Item 8 - Correspondence

RE: Administrative Subdivision M-NCPPC FILE No. 62020008A
5310 Moorland Lane and 5314 Moorland Lane ("Subject Property")

Re: Stormwater Management and Downstream Drainage Review and Comments
Administrative Subdivision #62020008A
Stormwater Management Concept Plan #287159
5310-5314 Moorland Lane and 7507 Glenbrook Road - Bethesda, MD 20814
O'C&L Project #021-024

Figure 1

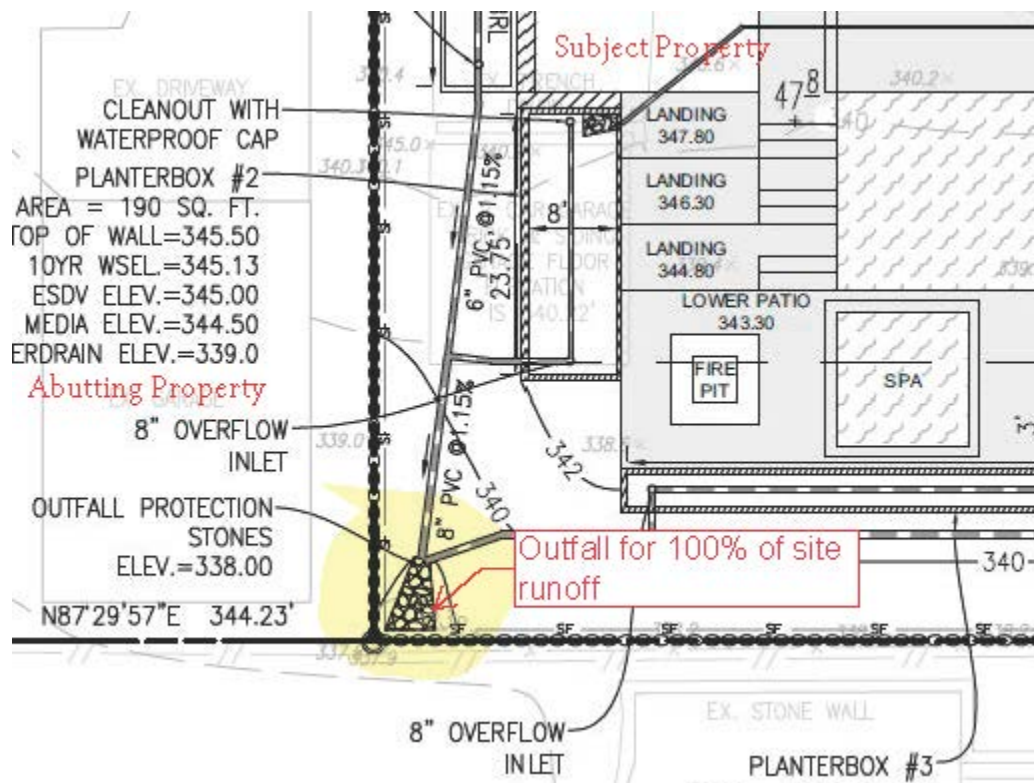
The oversized Subject Property combined with the significant level of impervious coverage results in significant runoff. The Staff Report, in reliance on the DPS concept plan approval, concludes that stormwater will be managed "on site" (p. 10). Instead, the concept plan as submitted to DPS would generate significant runoff onto the Abutting Property without permission of my clients. As explained by Douglas Tilley, P.E., R.P.L.S. in a report that will be filed separately, there is a strong likelihood based on the topography that there will be ponding water and/or runoff drainage onto my clients' property.

Figure 1, excerpted from the approved stormwater concept plan, shows the location of the sole outfall in the approved concept plan.

- a. Quantity volume of final westernmost planter box(es) must not exceed volume of Microbioretention Planter Box 1 and 2 on approved concept plan ("Western Planter Box").

- b. Outfall pipe for Western Planter Box on approved concept plan ("Western Planter Box") must be set a minimum of 13' from the western side property line ("Western Outfall").

- d. Outfall pipe for Microbioretention Planter Box 3 on approved concept plan must be separated from and located east of the Western Outfall.
- e. The designer of record must establish and analyze a study point at/near the rear property line just beyond the rip-rap outfall closest to the western side property line ("Western Outfall") demonstrating that runoff from a 10-year (ten-year) storm⁴ will not flow onto the property located at 5316 Moorland Lane ("Flow Analysis") and must submit the Flow Analysis for MCDPS review as part of the final Stormwater Management review during submission for sediment control permit and place on the sediment control plans for review/approval. The Flow Analysis must include: (i) volumetric quantity of pipe flow assuming full-flow capacity; (ii) computed volumetric flow from any planter box overflow; (iii) a rear property cross section beginning at the western property line, with a minimum 40' width and including the Western Outfall, that shows the depth of flow during the 10-year storm based on Manning's Formula; (iv) said depth of flow from the 10-year storm in item (iii) including the volumetric quantity from any outfall from Microbioretention Area 3 that impacts the 40' cross-section in addition to the volumetric flow from (i) and (ii); and (v) the Flow Analysis must evaluate the impact of any additional flow from draining from channelization proposed between the Western Planter Box and the site property line, including (a) natural flow from the 10-year storm that travels through channelization in this location; and (b) any anticipated overflow from the Western Planter Box. The overall

ADMINISTRATIVE SUBDIVISION PLAN #62020008A

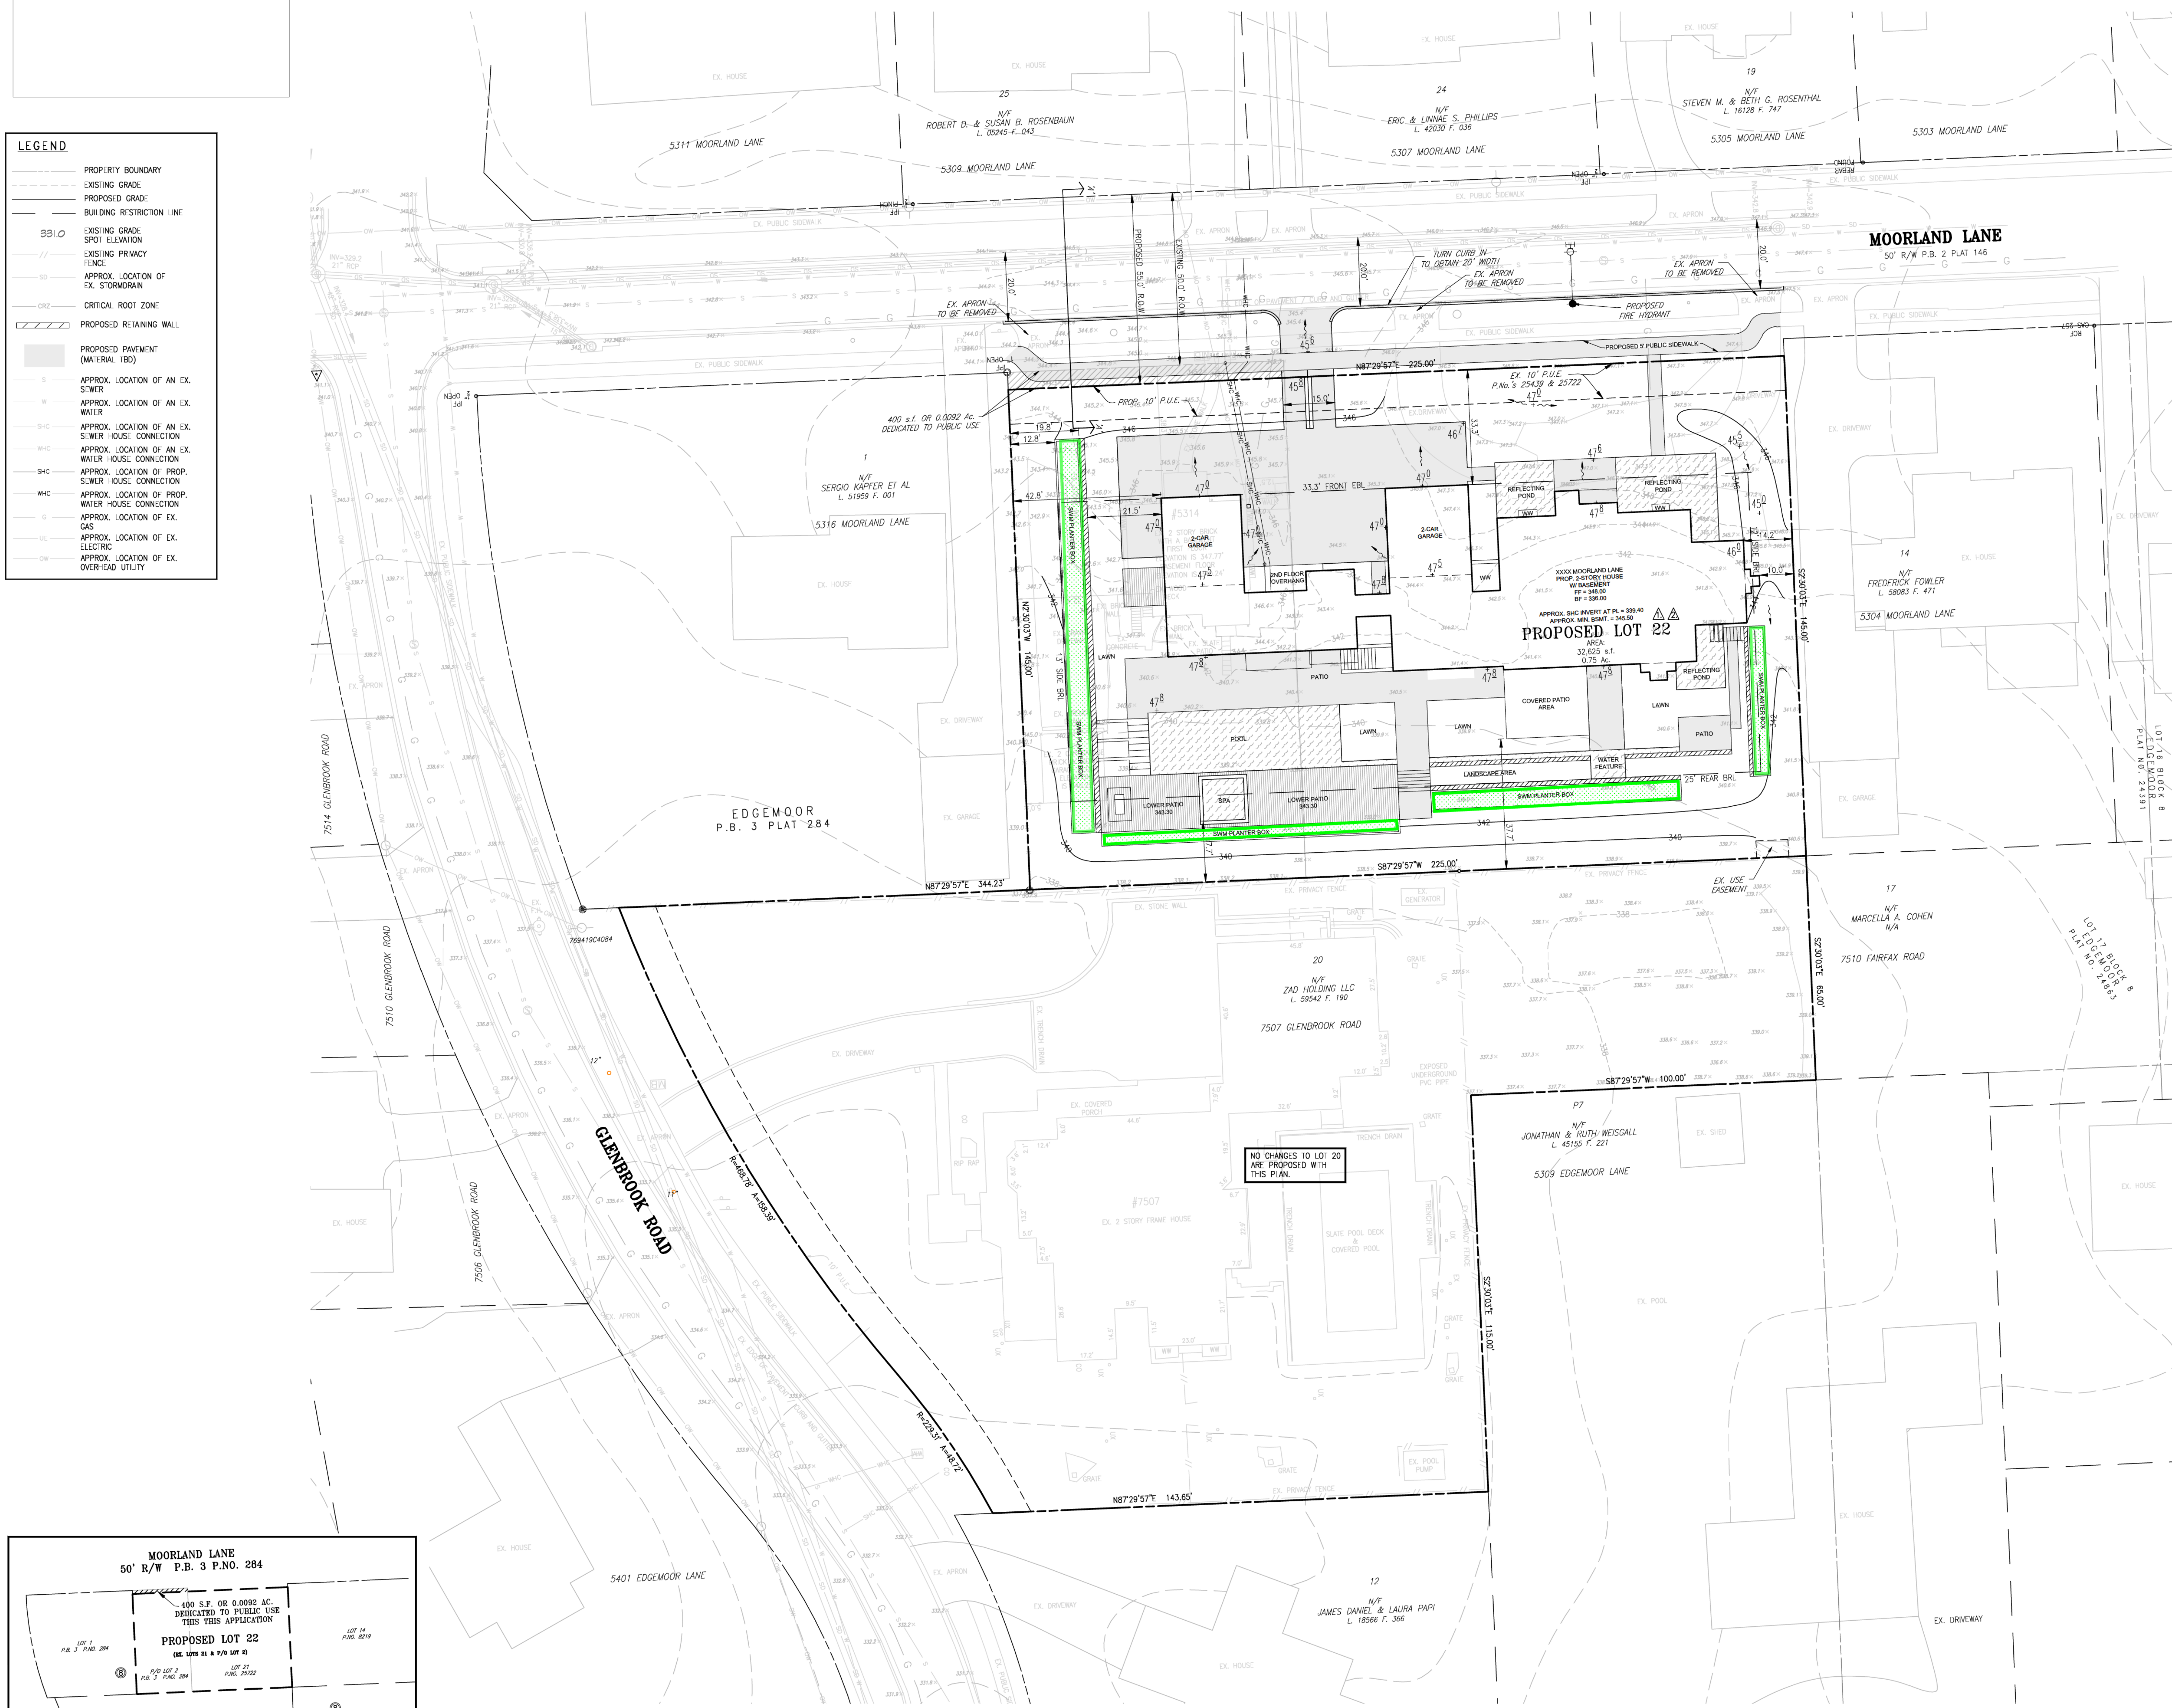
- Various versions of Administrative Subdivision Plan associated with the Subject Application. In particular, O'C&L most closely reviewed Sheet 4 of 6 of the Administrative Subdivision Plan filed as part of the Subject Application, prepared by CPJ, and signed and sealed on August 11, 2021. This drawing, as obtained from the DAIC, is attached to this letter as **Attachment A**.

The Administrative Subdivision Plan shows a series of four (4) Microbioretention Planter Boxes located generally along the side and rear walls of the proposed house or adjacent lawn/patio areas. In this plan, it appears to O’C&L that Microbioretention Planter Boxes 1 and 2 (as shown on the Approved Concept Plan) were combined into a single “SWM Planter Box” which parallels the western property line. This box appears to have been shifted to the east from the location of the Planter Boxes shown on the Approved Concept Plan. The overall size of this SWM Planter Box appears roughly consistent with the size of Microbioretention Planter Boxes 1 and 2, per the Approved Concept Plan. Outfall locations from the SWM Planter Boxes are not shown on the Administrative Subdivision Plan.
